Service Bulletin

no. 77-5

Subject: Fuel tank rubber mount

Models: Qualifier 250

Subject: Carburetor float adjustment

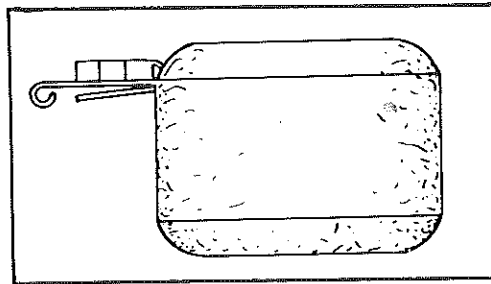
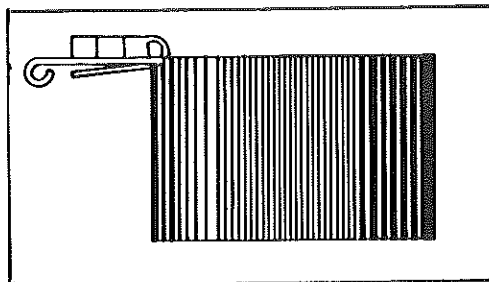
This year on the above mentioned models, we have two series of carburetors.

One series is equipped with white floats. The float height adjustment mentioned in the technical data, operator manual, etc..., is correct and applies only to the white floats model.

The other series is equipped with black floats, (its height must be adjusted to 22.5mm (.885")).

25mm (1")

ADJUSTMENT PROCEDURE

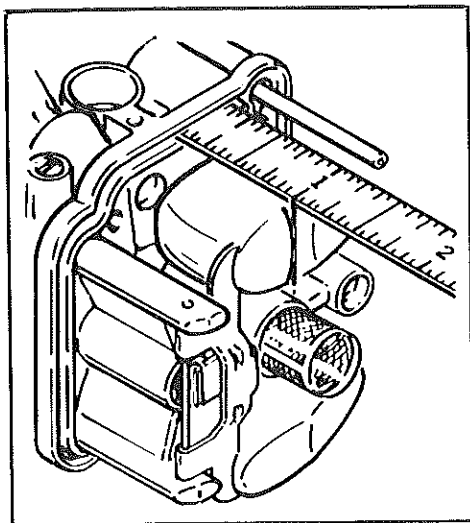
With carburetor on its side and with float adjustment tab just touching needle, measure distance between top of float and float chamber body (from the bottom of gasket groove).

To adjust, carefully bend adjustment tab of float arm until specified height is reached.

measure the height of
the float from the
bottom of gasket
groove

Subject: Center stand retaining cable

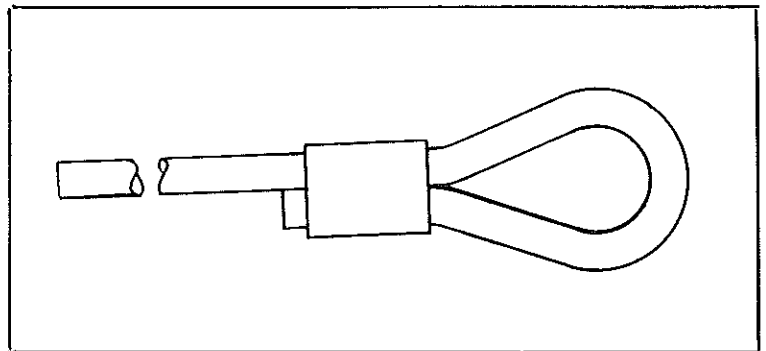
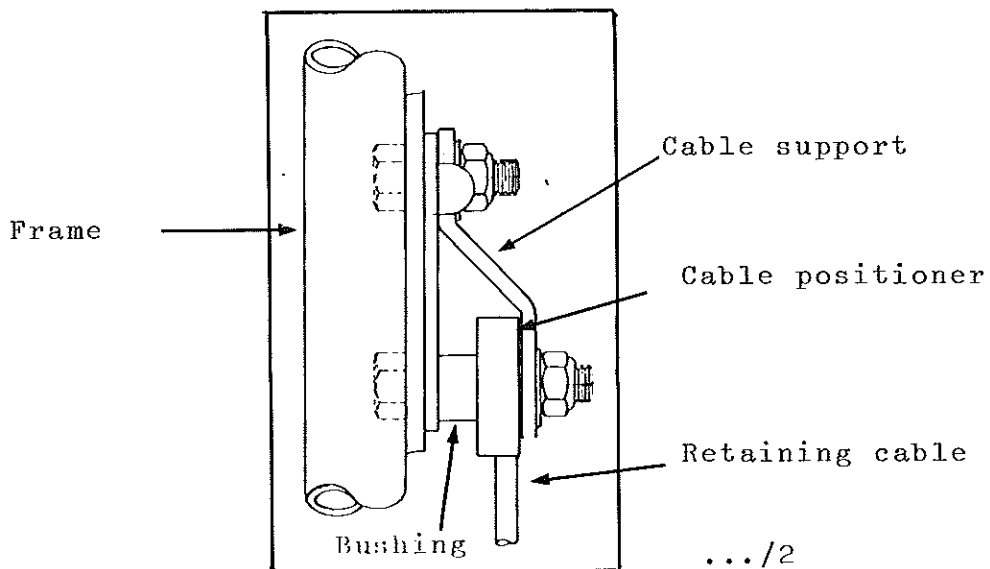
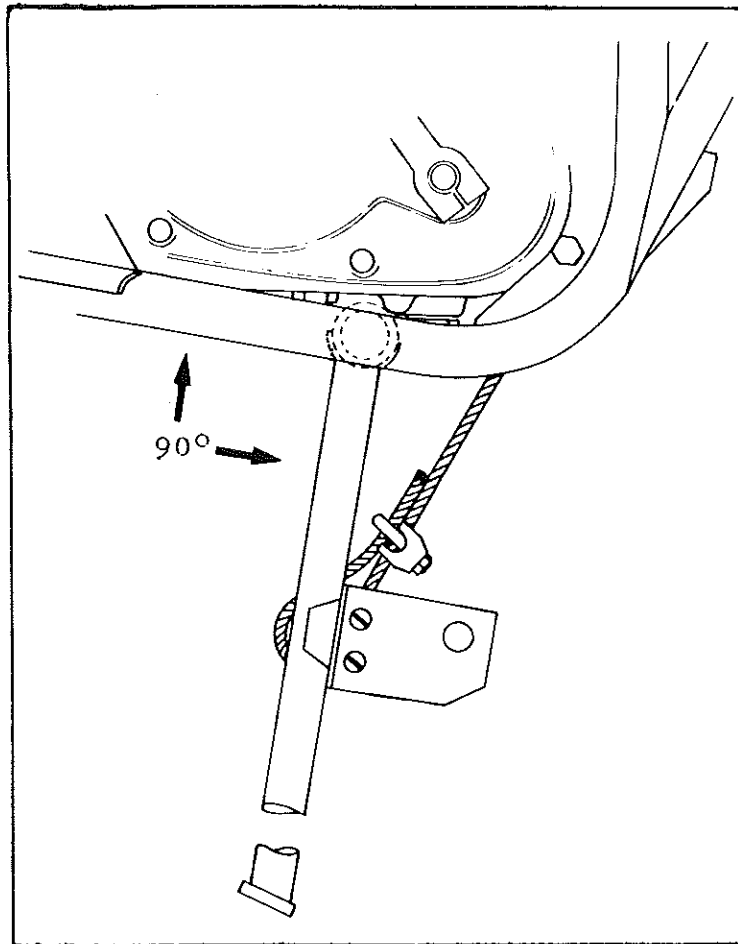
Replacement retaining cable parts are available under the following part numbers.

Secure the looped end of the cable to the frame.
Torque the retaining nuts to 2-2.8 kg-m (15-20 ft-lbs).

Route the straight end of the cable under the center stand cross tube and loop it over. Install and tighten the rope clip with the retaining nut facing backwards. Ensuring that the stand legs are forming a 90° angle with the frame.

Subject: LIGHTING SYSTEM

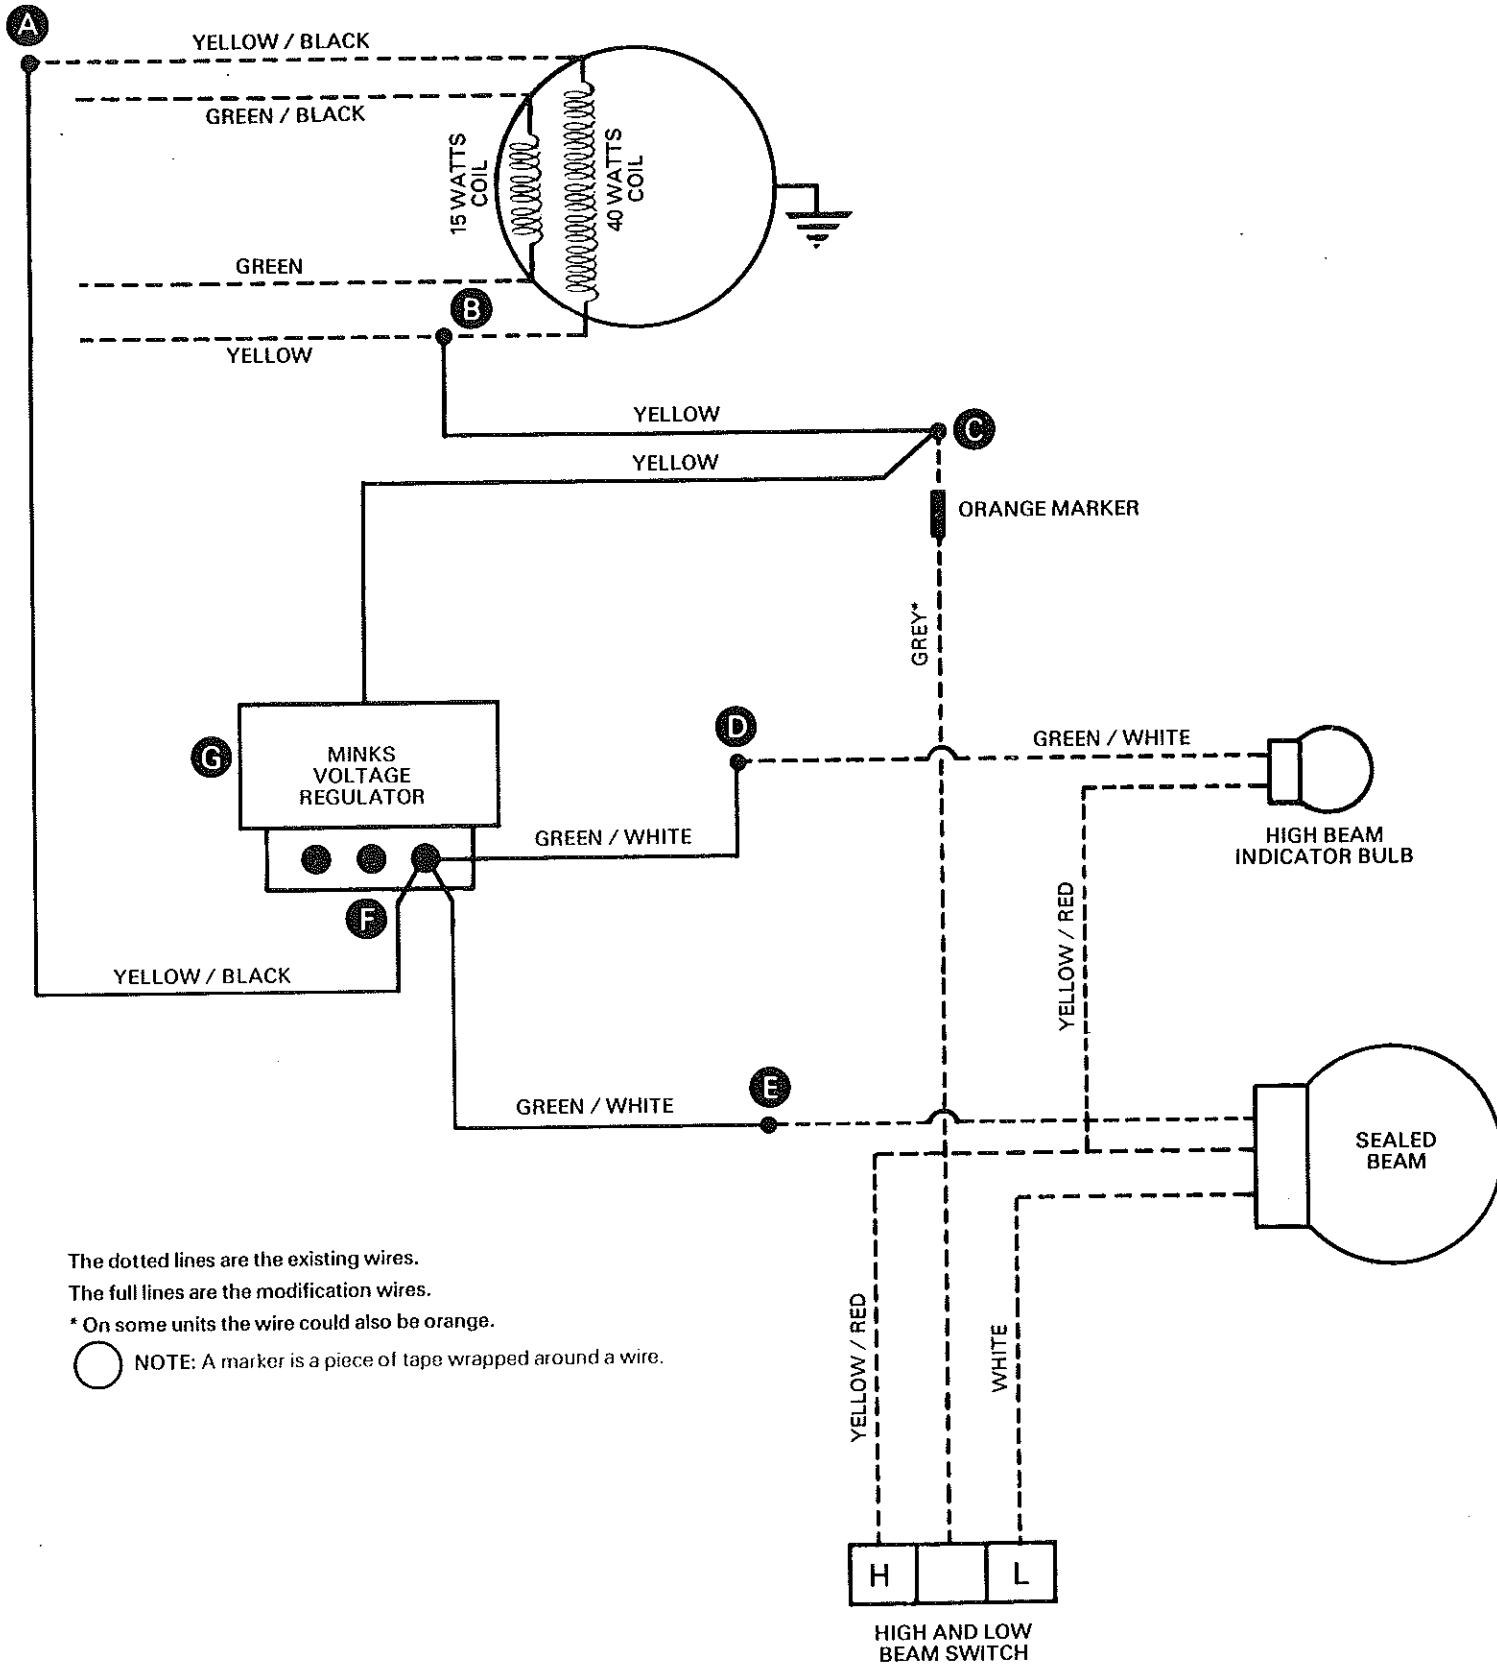
A modification can be made by connecting the head-lamp sealed beam and the high beam indicator lamp on a separate circuit, (directly to the lighting coil) therefore increasing battery charging.

The dotted lines are the existing wires.

The full lines are the modification wires.

Connect the wires at the rectifier level underneath the battery using joint connectors.

Locate the grey wire (leading from high / low beam switch) and disconnect it from the existing harness connections inside the headlamp housing. Using the 3-way receptacle. Connect the yellow wire leading from the lighting coil, the yellow wire leading from the MINKS® voltage regulator and the grey wire together. Ensure to install the large plastic cover.

Locate the green / white wire leading from the speedometer wiring and disconnect it from the existing harness connections inside the headlamp housing. Connect one of the 12" long green / white wire (using a female receptacle and a plastic cover) to the green / white wire leading from the speedometer harness.

Locate the green / white wire leading from the sealed beam socket and disconnect it from the existing harness connections inside the headlamp housing. Connect one of the 12" long green / white wire (using a female receptacle and a plastic cover) to the green / white wire of the sealed beam socket.

Install the open barrel (toothed) to the three following wires: yellow / black wire leading from the lighting coil, the two green / white wires leading from the high beam indicator bulb and the sealed beam socket, and secure it to the voltage regulator.

Subject: **SHOCK SPRING SELECTION**

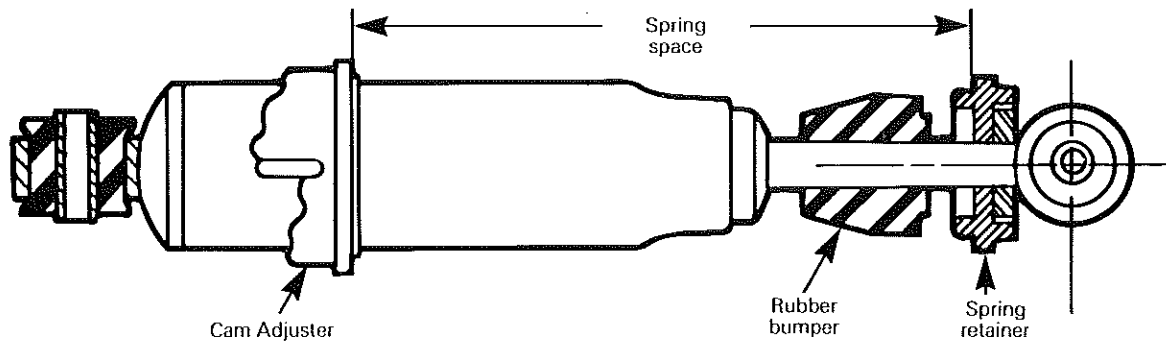
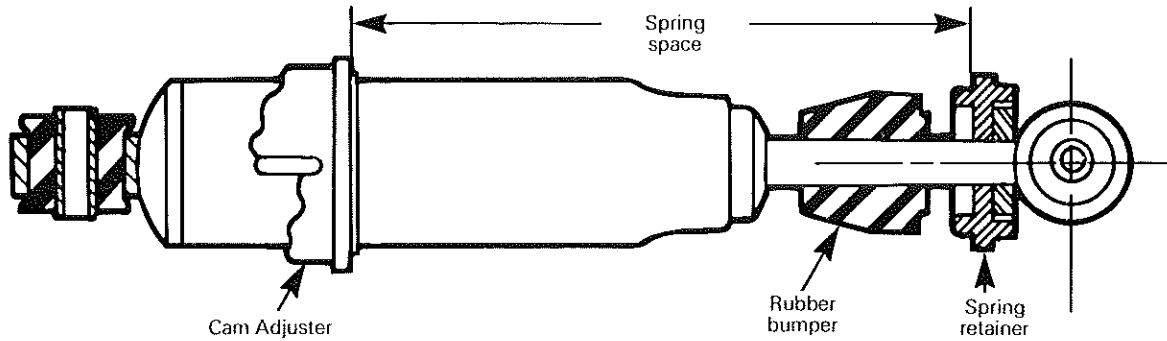
CAUTION: The choice of preload must be carefully selected to prevent any coil binding. The spring collapsed length must always be shorter than the space between the spring retainer and the cam adjuster when the shock is fully collapsed.

CAUTION: The shock spring 85 lb / in. must not be preloaded more than the 2nd position on the MX-3 175 and not more than the 1st position on the MX-3 250, coil binding will occur and cause damage.

The following chart gives the remaining space between the spring retainer and the cam adjuster with the cam at various position and the shock fully collapsed.
